# ACCESSIBILITY ASSESSMENT

July 13, 2021

## **ADA TITLE II ASSESSMENT**

Marlborough Town  
1847 Tanow Place  
District Heights, Maryland 20747

<b>Assembly</b>	Exterior Access Route
<b>Type</b>	Curb Ramp
<b>ADA Standard</b>	405.2; Table 405.2; 406; 406.2
<b>Barrier Detail</b>	The curb ramp does not meet the slope requirements.
<b>Location Description</b>	Curb Ramp CR1
<b>Observed</b>	May 20, 2021 by Ouraccessibleworld@gmail.com

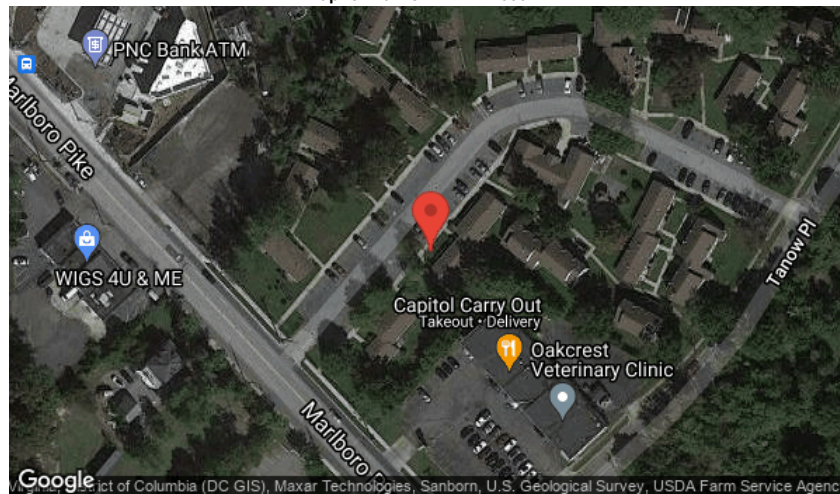
The left ramp run of the parallel curb ramp has a running slope of up to 11.3%.

The curb ramp should be removed and replaced with a compliant curb ramp with no greater than the maximum allowable slopes of a ramp. Curb ramp runs shall have a running slope not steeper than 1:12 (8.33%). Cross slope of curb ramp runs shall not be steeper than 1:48. The running slope in new construction shall be 1:12 (8.33%) maximum. [EXCEPTION: In existing sites, buildings, and facilities built before 1/26/92, ramps and curb ramps shall be permitted to have running slopes steeper than 1:12 where such slopes are necessary due to space limitations. In facilities built before 1/26/92, the running slope can be 1:10 to 1:8 (10% to 12.5%) for a maximum rise of 3" OR 1:10 to 1:12 (8.3% to 10%) for a maximum rise of 6".] Where flares are provided, flare slopes shall not be greater than 1:10 (10%). [EXCEPTION: In alterations, where there is no landing at the top of curb ramps, curb ramp flares shall be provided and shall not be steeper than 1:12.]

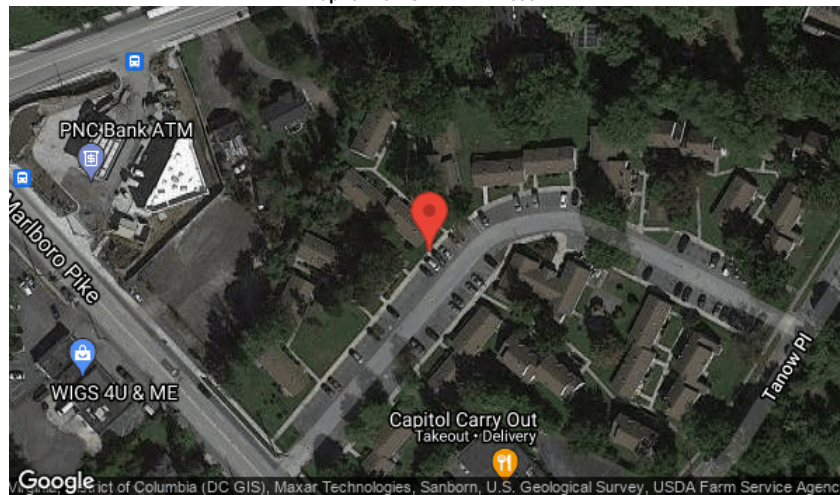
<b>Assembly</b>	Exterior Access Route
<b>Type</b>	Curb Ramp
<b>ADA Standard</b>	304, 406.4
<b>Barrier Detail</b>	The parallel curb ramp landing is not compliant.
<b>Location Description</b>	Curb Ramp CR3
<b>Observed</b>	May 20, 2021 by Ouraccessibleworld@gmail.com
<b>Site Conditions</b>	The bottom curb ramp landing has running slopes of up to 2.2%.

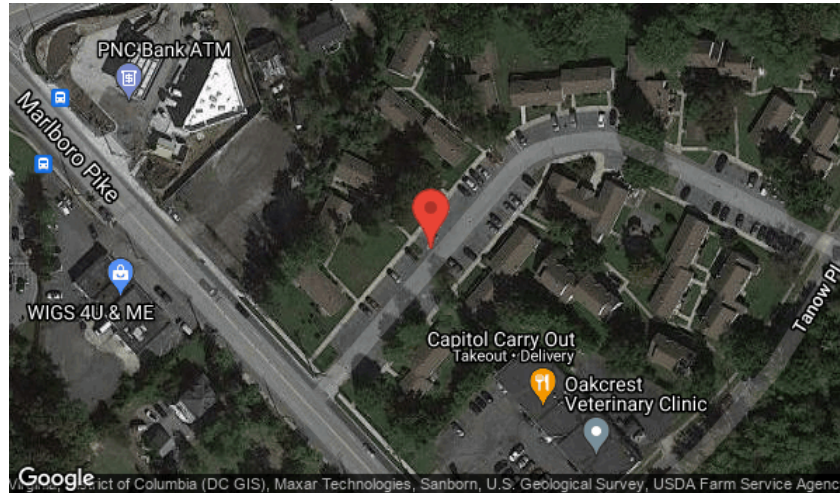
<b>Assembly</b>	Exterior Access Route
<b>Type</b>	Curb Ramp
<b>ADA Standard</b>	405.2; Table 405.2; 406; 406.2
<b>Barrier Detail</b>	The curb ramp does not meet the slope requirements.
<b>Location Description</b>	Curb Ramp CR4
<b>Observed</b>	May 20, 2021 by Ouraccessibleworld@gmail.com
<b>Site Conditions</b>	The curb ramp has a running slope of up to 11.9%.

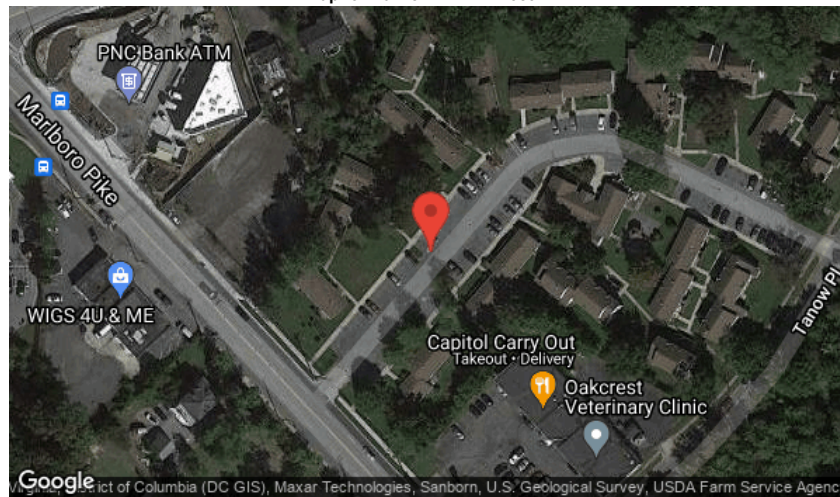
<b>Assembly</b>	Exterior Access Route
<b>Type</b>	Curb Ramp
<b>ADA Standard</b>	304, 406.4
<b>Barrier Detail</b>	The parallel curb ramp landing is not compliant.
<b>Location Description</b>	Curb Ramp CR4
<b>Observed</b>	May 20, 2021 by Ouraccessibleworld@gmail.com
<b>Site Conditions</b>	The bottom curb ramp landing has a running slope of up to 3.8%.

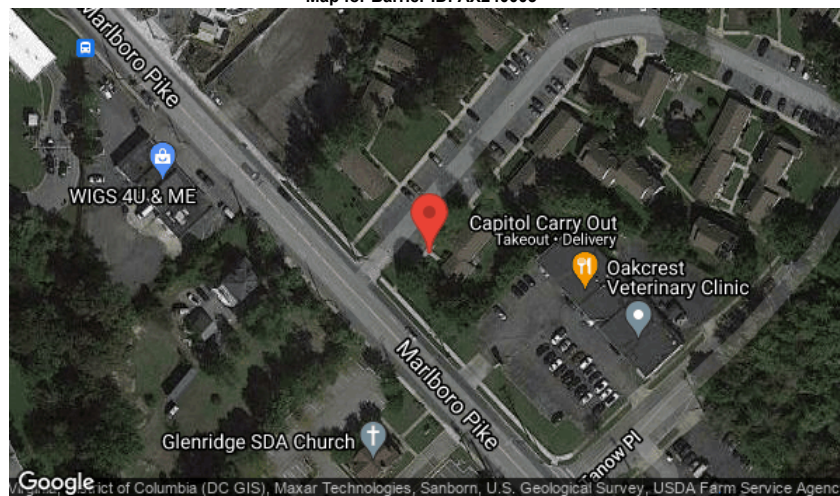
The accessible route has a cross slope of up to 3.0% for a distance of approximately 330' by 5' wide.

The walkway should be graded to a maximum 1:50 (2%) cross slope. An accessible route has maximum 1:20 (5%) running slope and maximum 1:50 (2%) cross slope. [EXCEPTION: Cross slopes not exceeding 1:48 (2.08%) are permitted.] The clear width of walking surfaces shall be 36" minimum. [EXCEPTION: The clear width shall be permitted to be reduced to 32" minimum for a length of 24" maximum provided that reduced width segments are separated by segments that are 48" long minimum and 36" wide minimum.] Where grading to maximum running slope of 1:20 (5% running slope) is not possible, provide a compliant ramped surface within the walkway with maximum slope 1:12 (8.33%) and maximum ramp run rise of 6" without handrails. If a ramped surface with running slopes greater than 1:20 (5%) and maximum 1:12 (8.33%) rises more than 6", handrails are required. The cost estimate for this barrier removal is based on grading the running slope to maximum 1:20 (5%). The quantity and order of magnitude cost estimate provided for this barrier are limited to the extent of the area identified as non-compliant. Additional costs that may be associated with removal of the barrier are not included.

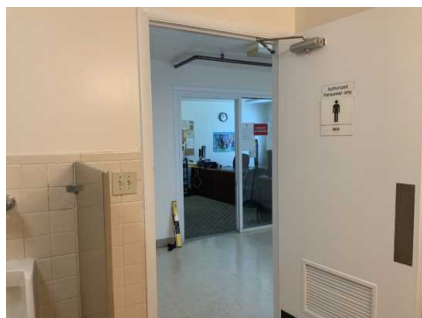
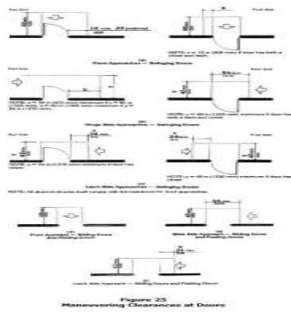
<b>Assembly</b>	Restroom
<b>Type</b>	Restroom/Bathroom-Door
<b>ADA Standard</b>	UFAS 4.22.2; 4.13.6; Fig. 25
<b>Barrier Detail</b>	The restroom door does not have a compliant maneuvering clearance area.
<b>Location Description</b>	Leasing Office Men's Restroom
<b>Observed</b>	May 20, 2021 by Ouraccessibleworld@gmail.com
<b>Site Conditions</b>	For a front approach on the pull side the side clearance is 15".

Replace the maneuvering clearance area. Provide compliant level and clear maneuvering clearances at accessible doors. Redesign to provide the required maneuvering clearance at the door. The required depth of the maneuvering clearance is 60" minimum. The required side clearance is 18" minimum on the latch side of the door. Maneuvering clearance shall extend the full width of the doorway and the required latch side clearance. Changes in level are not permitted. Minimum maneuvering clearances at doors that are not automatic or power-assisted shall be as shown in Fig. 25. The floor or ground area within the required clearances shall be level and clear.

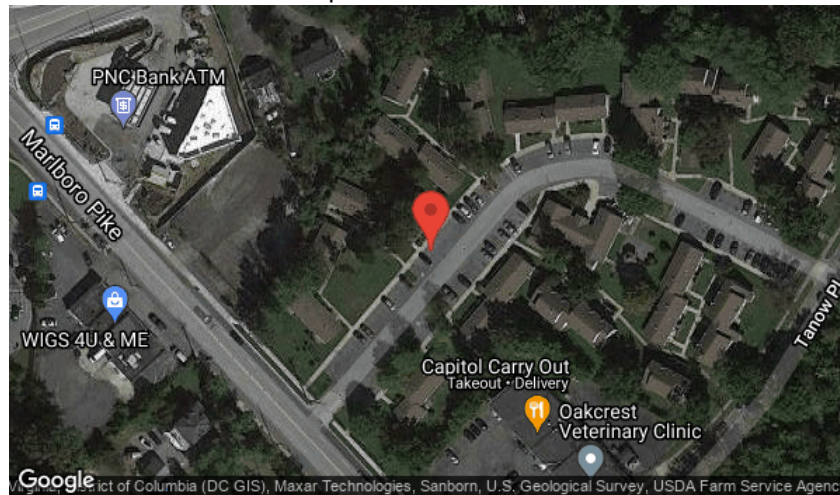
<b>Assembly</b>	Accessible Parking
<b>Type</b>	Parking Space-Car
<b>ADA Standard</b>	UFAS 4.6.3
<b>Barrier Detail</b>	The slope of the standard car parking space is greater than 1:50 (2%).
<b>Location Description</b>	P1-1 and P1-2
<b>Observed</b>	May 20, 2021 by Ouraccessibleworld@gmail.com
<b>Site Conditions</b>	The parking spaces have a running slope of up to 5.3%.

Remove and replace with a parking space that has no more than 1:50 (2%) slope in all directions. Parking spaces for disabled people shall be at least 96" wide and shall have an adjacent access aisle 60" wide minimum (see Fig. 9). [EXCEPTION: If accessible parking spaces for vans are provided, each should have an adjacent access aisle at least 96" wide.] Parking access aisles shall be part of an accessible route to the building or facility entrance. Two accessible parking spaces may share a common access aisle. Parked vehicle overhangs shall not reduce the clear width of an accessible circulation route. Parking spaces and access aisles shall be level with surface slopes not exceeding 1:50 in all directions. The quantity and order of magnitude cost estimate provided for this barrier are limited to the extent of the area identified as non-compliant. Additional costs that may be associated with removal of the barrier are not included.

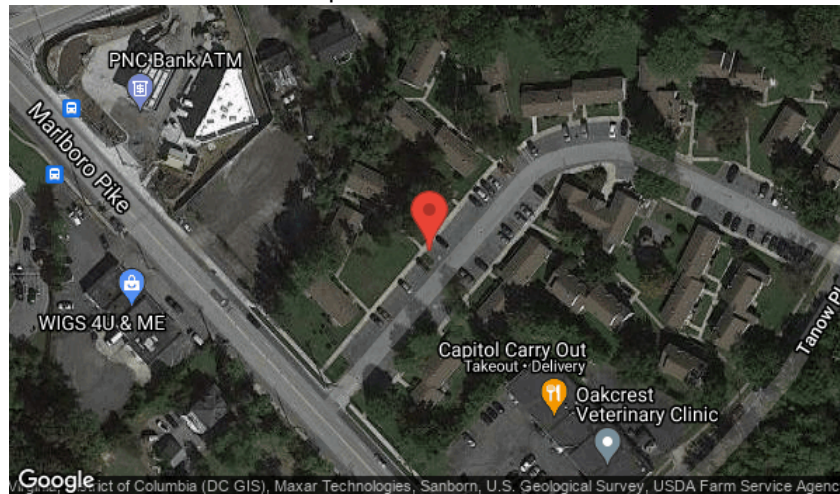
<b>Assembly</b>	Accessible Parking
<b>Type</b>	Parking Space-Car
<b>ADA Standard</b>	UFAS 4.6.3
<b>Barrier Detail</b>	The slope of the standard car access aisle is greater than 1:50 (2%).
<b>Location Description</b>	P1-1 and P1-2
<b>Observed</b>	May 20, 2021 by Ouraccessibleworld@gmail.com
<b>Site Conditions</b>	The access aisle has a running g slope of up to 4.6%.

Remove and replace with an adjacent access aisle that is at least 60" wide and has a maximum slope of 1:50 (2%) in all directions. Parking spaces and access aisles shall be level with surface slopes not exceeding 1:50 in all directions. Parking access aisles shall be part of an accessible route to the building or facility entrance. Parked vehicle overhangs shall not reduce the clear width of an accessible circulation route. The quantity and order of magnitude cost estimate provided for this barrier are limited to the extent of the area identified as non-compliant. Additional costs that may be associated with removal of the barrier are not included.

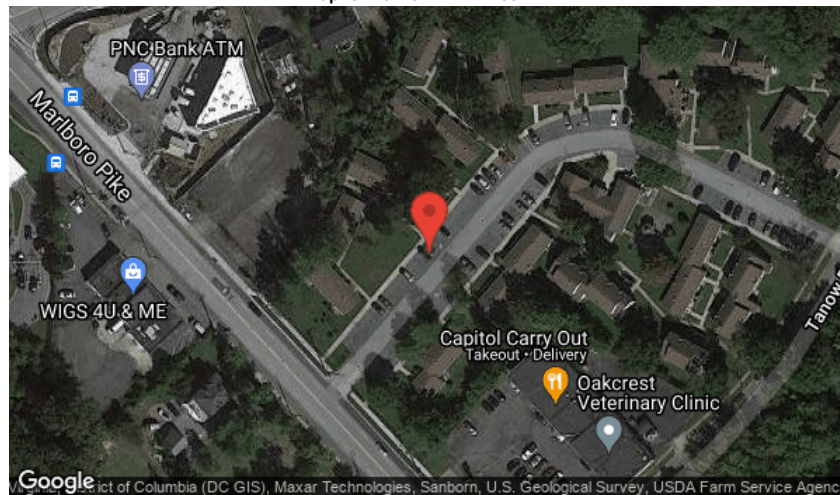
<b>Assembly</b>	Accessible Parking
<b>Type</b>	Parking Space-Car
<b>ADA Standard</b>	UFAS 4.6.4
<b>Barrier Detail</b>	The standard car parking stall signage is not compliant.
<b>Location Description</b>	P1-1 and P1-2
<b>Observed</b>	May 20, 2021 by Ouraccessibleworld@gmail.com
<b>Site Conditions</b>	The standard space signage does not have fine information provided.

Provide signage for the standard car parking stall showing the International Symbol of Accessibility. Accessible parking spaces shall be designated as reserved for the disabled by a sign showing the International Symbol of Accessibility. Such signs shall not be obscured by a vehicle parked in the space. This barrier applies only to non-public parking in residential developments. Other applicable federal, state and local regulations may supercede this barrier, and have stricter requirements.

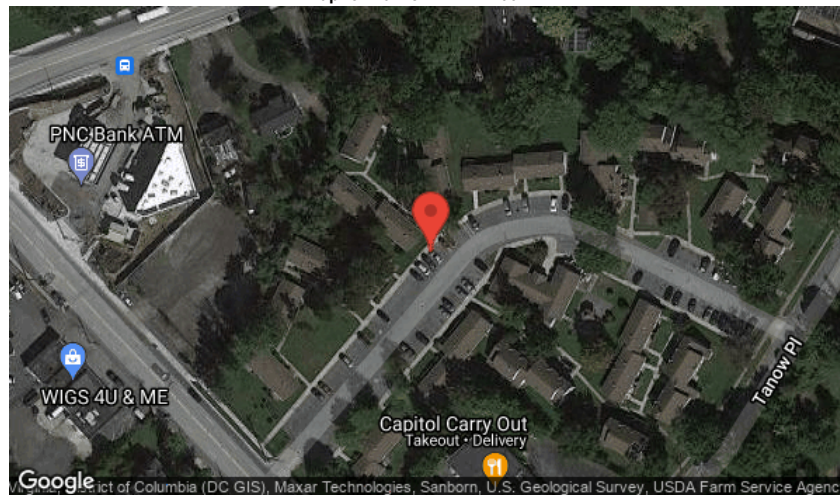
<b>Assembly</b>	Accessible Parking
<b>Type</b>	Parking Space-Car
<b>ADA Standard</b>	UFAS 4.6.4
<b>Barrier Detail</b>	The standard car parking stall signage is not compliant.
<b>Location Description</b>	P1-3 and P1-4
<b>Observed</b>	May 20, 2021 by Ouraccessibleworld@gmail.com
<b>Site Conditions</b>	The standard accessible signage does not contain information on fines.

Provide signage for the standard car parking stall showing the International Symbol of Accessibility. Accessible parking spaces shall be designated as reserved for the disabled by a sign showing the International Symbol of Accessibility. Such signs shall not be obscured by a vehicle parked in the space. This barrier applies only to non-public parking in residential developments. Other applicable federal, state and local regulations may supercede this barrier, and have stricter requirements.

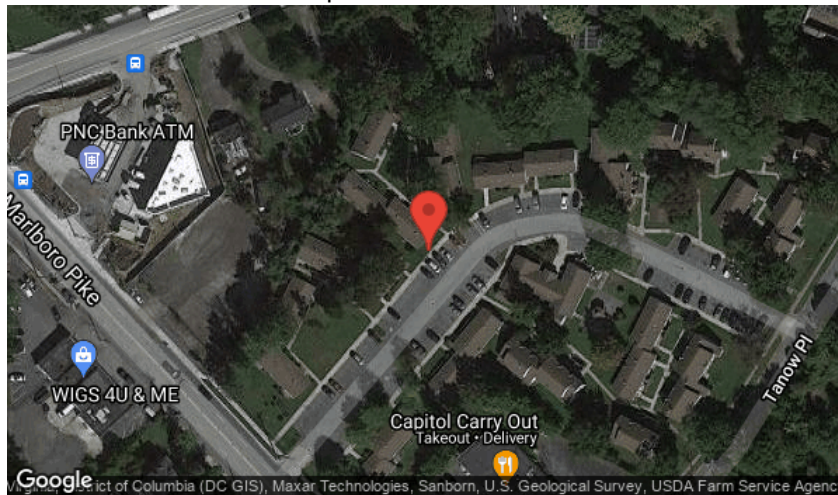
<b>Assembly</b>	Accessible Parking
<b>Type</b>	Parking Space-Car
<b>ADA Standard</b>	UFAS 4.6.3
<b>Barrier Detail</b>	The slope of the standard car parking space is greater than 1:50 (2%).
<b>Location Description</b>	P1-4
<b>Observed</b>	May 17, 2021 by Ouraccessibleworld@gmail.com
<b>Site Conditions</b>	The accessible space has a vertical change of up to 3 1/2".

Remove and replace with a parking space that has no more than 1:50 (2%) slope in all directions. Parking spaces for disabled people shall be at least 96" wide and shall have an adjacent access aisle 60" wide minimum (see Fig. 9). [EXCEPTION: If accessible parking spaces for vans are provided, each should have an adjacent access aisle at least 96" wide.] Parking access aisles shall be part of an accessible route to the building or facility entrance. Two accessible parking spaces may share a common access aisle. Parked vehicle overhangs shall not reduce the clear width of an accessible circulation route. Parking spaces and access aisles shall be level with surface slopes not exceeding 1:50 in all directions. The quantity and order of magnitude cost estimate provided for this barrier are limited to the extent of the area identified as non-compliant. Additional costs that may be associated with removal of the barrier are not included.

<b>Assembly</b>	Exterior Access Route
<b>Type</b>	Exterior Accessible Route
<b>ADA Standard</b>	UFAS 4.3.7
<b>Barrier Detail</b>	The accessible route cross slope is greater than 1:50 (2%).
<b>Location Description</b>	Sidewalk To Unit 1925
<b>Observed</b>	May 20, 2021 by Ouraccessibleworld@gmail.com

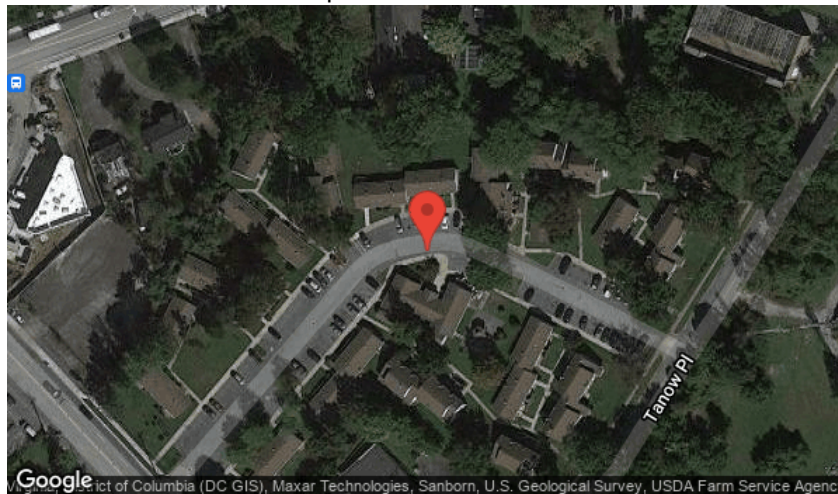
The accessible route has a cross slope of up to 3.1% for a distance of approximately 60' by 4' wide.

Remove and replace the accessible route with a compliant cross slope not greater than 1:50 (2%). An accessible route has maximum 1:50 (2%) cross slope, maximum 1:20 (5%) running slope, and minimum 36" clear width. [EXCEPTION: The accessible route may be minimum 32" wide at doors/gates or at a point]. An accessible route with a running slope greater than 1:20 is a ramp. Nowhere shall the cross slope of an accessible route exceed 1:50. The minimum clear width of an accessible route shall be 36" except at doors. If an accessible route has less than 60" clear width, then passing spaces at least 60" by 60" shall be located at reasonable intervals not to exceed 200 linear feet. A T-intersection of two corridors or walks is an acceptable passing place. Where grading to maximum running slope of 1:20 (5% running slope) is not possible, provide a compliant ramped surface within the walkway with maximum slope 1:12 (8.33%) and maximum ramp run rise of 6" without handrails. If a ramped surface with running slopes greater than 1:20 (5%) and maximum 1:12 (8.33%) rises more than 6" or extends more than 72", handrails are required. A compliant ramp has maximum 1:12 (8.3%) running slope, maximum ramp run rise 30", landings at the top and bottom of ramp runs, handrails where the ramp run rise is greater than 6" or extends more than 72", and edge protection with exceptions. The cost estimate for this barrier removal is based on grading the running slope to maximum 1:20 (5%). The quantity and order of magnitude cost estimate provided for this barrier are limited to the extent of the area identified as non-compliant. Additional costs that may be associated with removal of the barrier are not included.

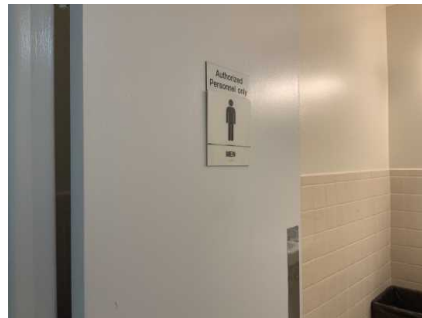
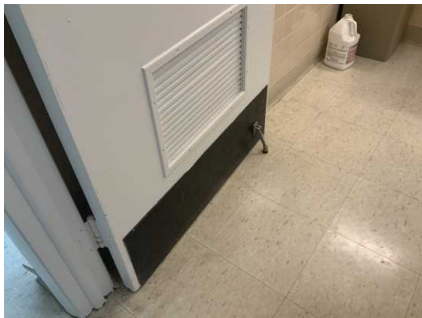
The hold open hardware interferes with the required smooth surface of the door.

Provide a swinging door with a smooth surface within 10" of the finish floor or ground measured vertically on the push side extending the full width of the door. Parts creating horizontal or vertical joints in the surfaces shall be within 1/16" of the same plane as the other. Cavities created by adding kick plates shall be capped.

<b>Location Description</b>	Leasing Office Men's Restroom
<b>Observed</b>	May 20, 2021 by Ouraccessibleworld@gmail.com
<b>Site Conditions</b>	The door has locking hardware that requires tight grasping to operate.

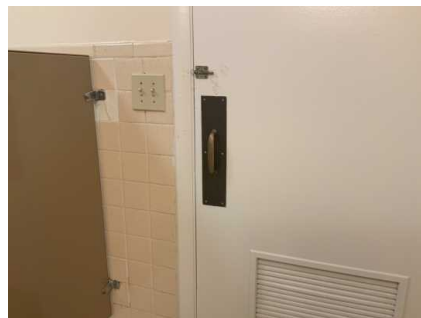
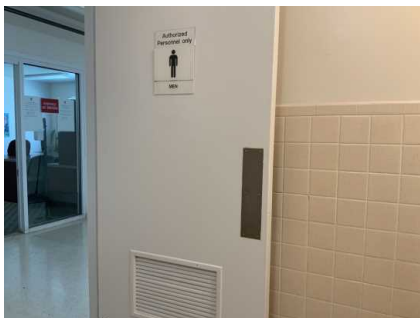
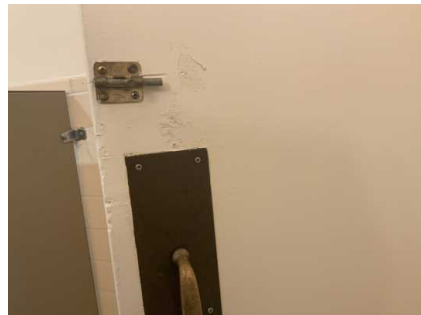
The hardware at the accessible door requires tight grasping, pinching or twisting of the wrist to operate.

Remove hardware and replace with hardware that has a shape that is easy to grasp such as lever, push-type or U-shaped handles. Handles, pulls, latches, locks, and other operating devices on accessible doors shall have a shape that is easy to grasp with one hand and does not require tight grasping, tight pinching, or twisting of the wrist to operate. Lever-operated mechanisms, push-type mechanisms, and U-shaped handles are acceptable designs. When sliding doors are fully open, operating hardware shall be exposed and usable from both sides. In dwelling units, only doors at accessible entrances to the unit itself shall comply. Mount hardware required for accessible door passage no higher than 48" above finished floor. Doors to hazardous areas shall have hardware complying with the following: Doors that lead to areas that might prove dangerous to a blind person (for example, doors to loading platforms, boiler rooms, stages, and the like) shall be made identifiable to the touch by a textured surface on the door handle, knob, pull or other operating hardware. This textured surface may be made by knurling or roughing or by a material applied to the contact surface. Such textured surfaces shall not be provided for emergency exit doors or any doors other than those to hazardous areas.

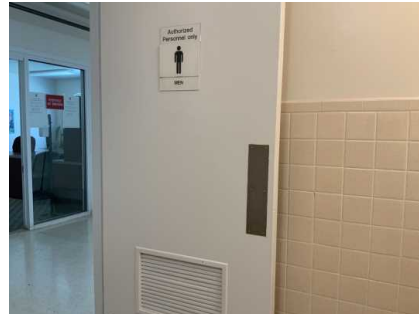
The door has a closing speed of up to 3.81 seconds from 90 degrees to a position 12 degrees from latch.

Adjust closer "OR" Remove and replace closer to ensure that the door has a closure time of at least 5 seconds within 12 degrees of the latch. Door closers and gate closers shall be adjusted so that from an open position of 90 degrees, the time required to move the door to a position of 12 degrees from the latch is 5 seconds minimum.

<b>Location Description</b>	Leasing Office Women's Restroom
-----------------------------	---------------------------------

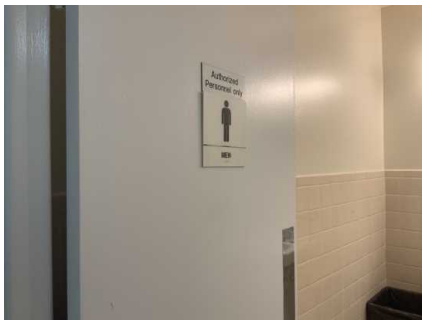
The door hardware on the women's restroom requires tight grasping and twisting to operate.

Remove hardware and replace with hardware that has a shape that is easy to grasp such as lever, push-type or U-shaped handles. Handles, pulls, latches, locks, and other operating devices on accessible doors shall have a shape that is easy to grasp with one hand and does not require tight grasping, tight pinching, or twisting of the wrist to operate. Lever-operated mechanisms, push-type mechanisms, and U-shaped handles are acceptable designs. When sliding doors are fully open, operating hardware shall be exposed and usable from both sides. In dwelling units, only doors at accessible entrances to the unit itself shall comply. Mount hardware required for accessible door passage no higher than 48" above finished floor. Doors to hazardous areas shall have hardware complying with the following: Doors that lead to areas that might prove dangerous to a blind person (for example, doors to loading platforms, boiler rooms, stages, and the like) shall be made identifiable to the touch by a textured surface on the door handle, knob, pull or other operating hardware. This textured surface may be made by knurling or roughing or by a material applied to the contact surface. Such textured surfaces shall not be provided for emergency exit doors or any doors other than those to hazardous areas.

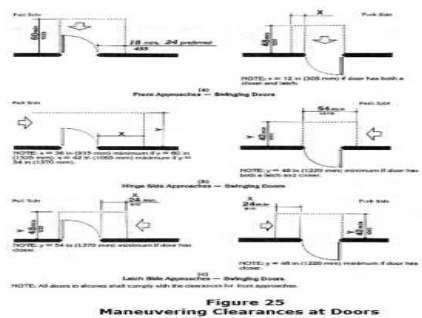
<b>Assembly</b>	Residential Dwelling
<b>Type</b>	Door
<b>ADA Standard</b>	UFAS 4.13.6; Fig. 25
<b>Barrier Detail</b>	The door does not have a compliant maneuvering clearance area.
<b>Location Description</b>	Unit 1847, 1921, 1923 and 1925
<b>Observed</b>	May 20, 2021 by Ouraccessibleworld@gmail.com
<b>Site Conditions</b>	For a front approach on the pull side the side clearance is 14" .

Redesign to provide the required maneuvering clearance at the door. Provide compliant level and clear maneuvering clearances at accessible doors. The required depth of the maneuvering clearance is 60" minimum. The required side clearance is 18" minimum on the latch side of the door. Maneuvering clearance shall extend the full width of the doorway and the required latch side clearance. Changes in level are not permitted. Minimum maneuvering clearances at doors that are not automatic or power-assisted shall be as shown in Fig. 25. The floor or ground area within the required clearances shall be level and clear.
